MFN No. 010-92
Docket No. STN 50-605
EEN-9206

Subject: GE Response to Agenda Items 1,5,9 and 16 Discussed During the
GE/NRC Reactor Systems Branch Meeting on November 20-21,
1991

RESPONSE TO ITEM 1:

Figure 1. ABWR Stability

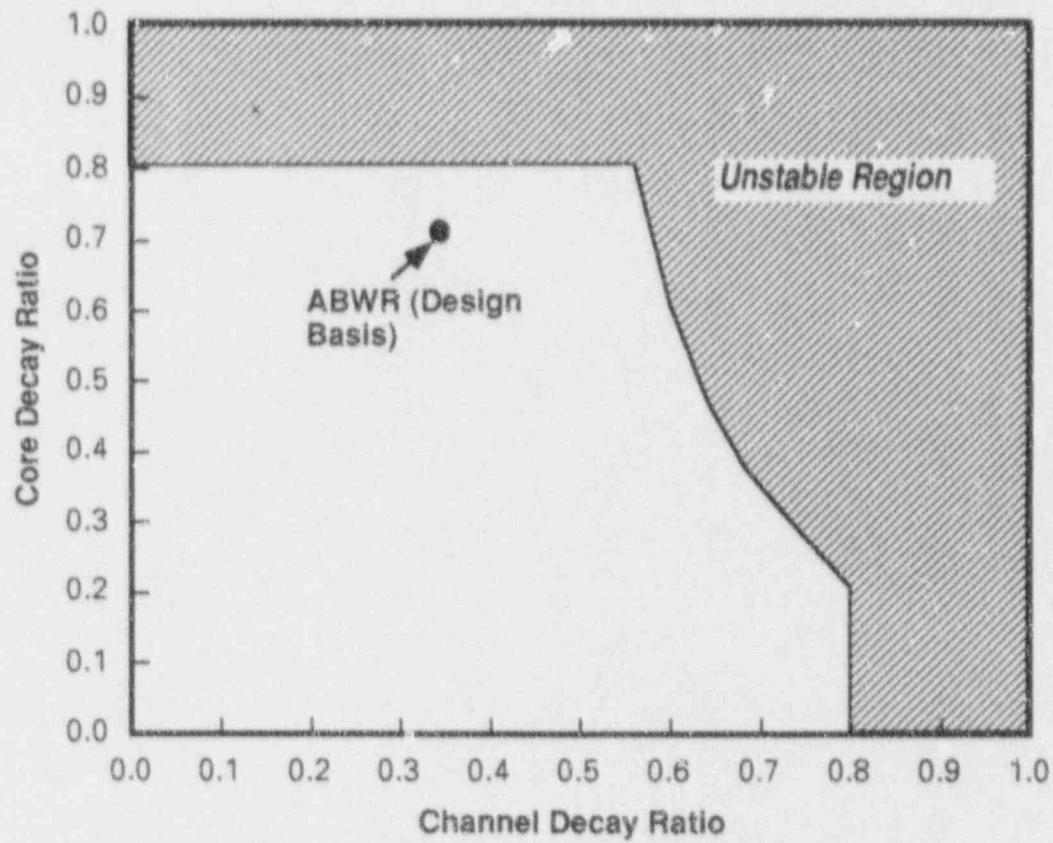
In order to reconfirm this conclusion, a stability analysis based on the procedures developed by the BWROG committee on thermal hydraulic stability (Reference 1) was performed for the ABWR. In this analysis, conservative nuclear conditions, taking into consideration of future core design, were assumed. The results at the most limiting conditions in the normal operating region (i.e.; the intercept of 102 % rod line with all operating RIPS at their minimum speeds, assuming only 9 out of 10 RIPS are in operation) are as follows:

These results are also shown in Figure 1 together with the criteria. From Figure 1, it is confirmed that that ABWR is stable in the normal operating region.

Figure 2. Stability Controls and Protection Logic

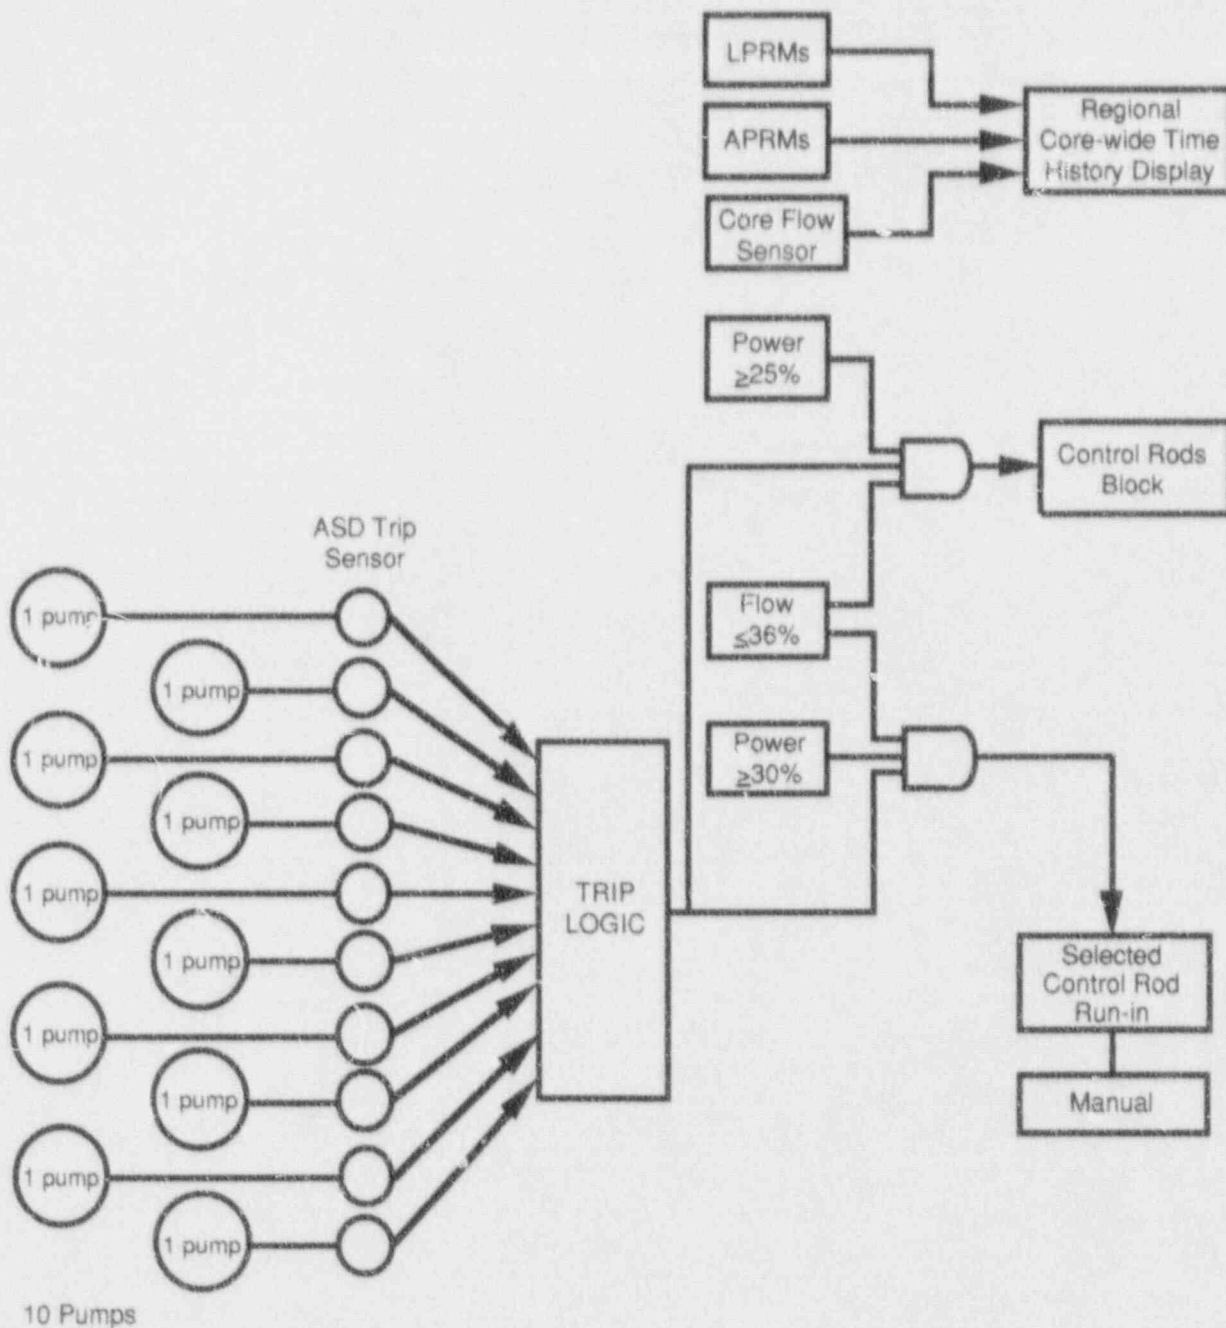
Furthermore, automatic logics (Figure 2) which prevent plant operation in the region with the least stability margin are also implemented. This design is similar to Option I-A, one of long-term solutions considered by the BWROG. In addition, in order to meet the stability design requirements specified in the ALWR Utility Requirements Document, Option III, LPRM based Oscillation Power Range Monitor (OPRM), which is also one of long-term solutions considered by the BWROG, will be implemented in the ABWR design, when the OPRM design is approved by the NRC.

Figure 10.1-1 REFERENCE STEAM & POWER CONVERSION SYSTEM

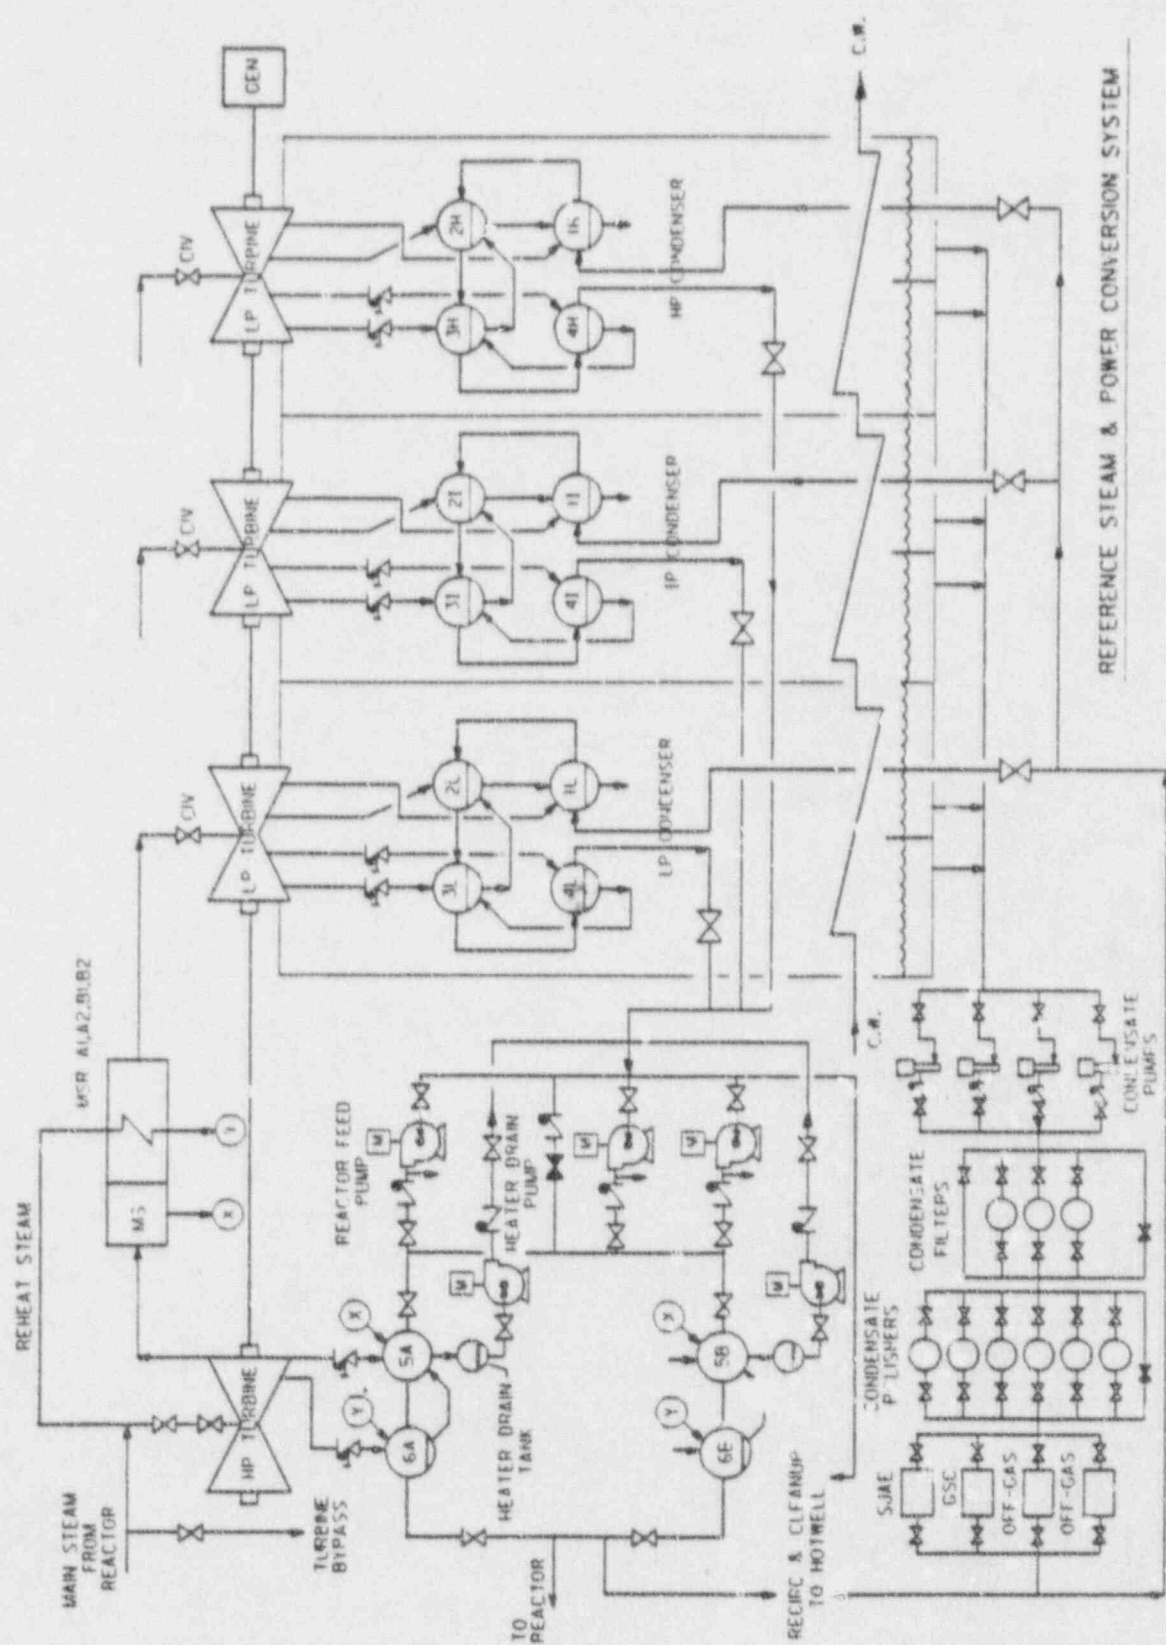
The reference steam and power conversion system shown in Figures 10.1-1 to 10.1-3 meets this requirement. In fact, the FW temperature drop based on the reference heat balance shown in Figure 10.1-2 is as follows:

- isolation of one low pressure heater < 15 °F
- isolation of one high pressure heater < 28 °F
- isolation of one low pressure heater string < 53 °F
- isolation of one high pressure heater string < 53 °F

Therefore, the use of 100 °F temperature drop in the transient analysis is conservative.
